TECHNICAL REVIEW AND EVALUATION
OF THERMAL EFFECTS STUDIES AND
COOLING WATER INTAKE STRUCTURE
DEMONSTRATION OF IMPACT FOR THE
OYSTER CREEK NUCLEAR
GENERATING STATION

REVISED FINAL REPORT

New Jersey Department of
Environmental Protection
Division of Water Resources
401 E. State Street
Trenton, NJ 08625

May 1989

Figure IV-2. Forked River mouth surface temperature and associated environmental data June 24-July 16, 1974 (from JCP&L 1978)

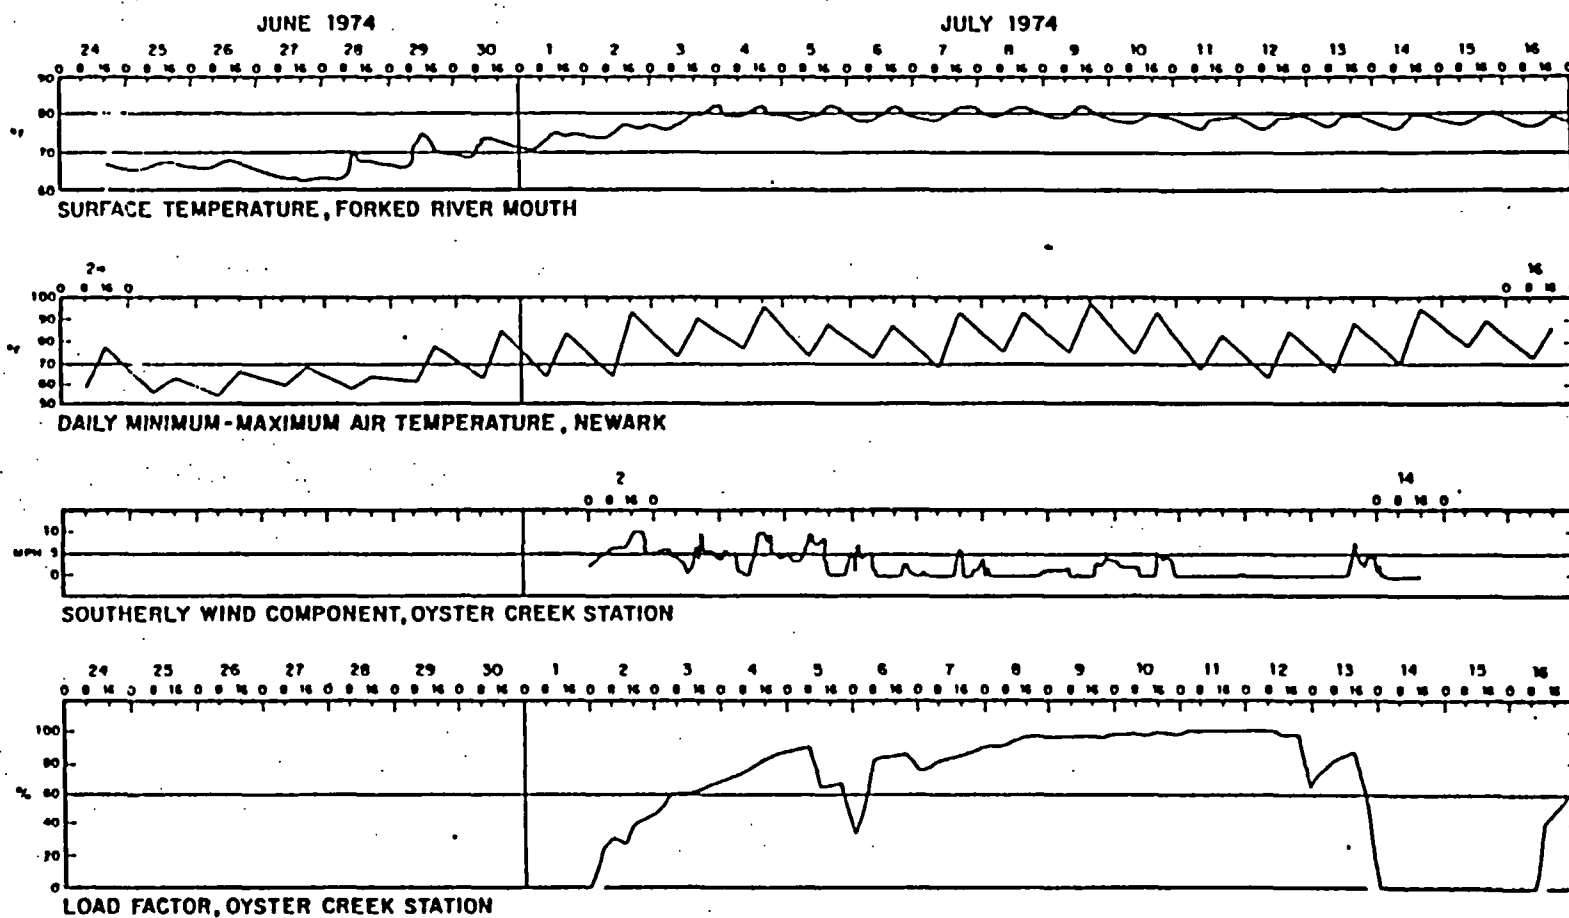
In order to estimate recirculation of heated water, GPUN monitored the Forked River intake temperature for 23 days and compared the intake temperature time series with a time series

of power production by the Oyster Creek NGS, Newark air temperature, and the southerly wind component. Intake temperature qualitatively tracked air temperature, and based on this finding GPUN concluded that recirculation was small, and that intake temperature was a reasonable estimate of ambient temperature (Figure IV-2). Clearly, this analysis and its interpretation does not reach a reasonable conclusion. A relationship appears to exist between Forked River water temperature, and the interaction of power production of the Oyster Creek NGS and wind condition. Without the raw data used to construct Figure IV-2 this relationship cannot be tested. In addition, this study completely ignored earlier indications of recirculation obtained from the dye studies as well as the thermal plume mapping overflights.
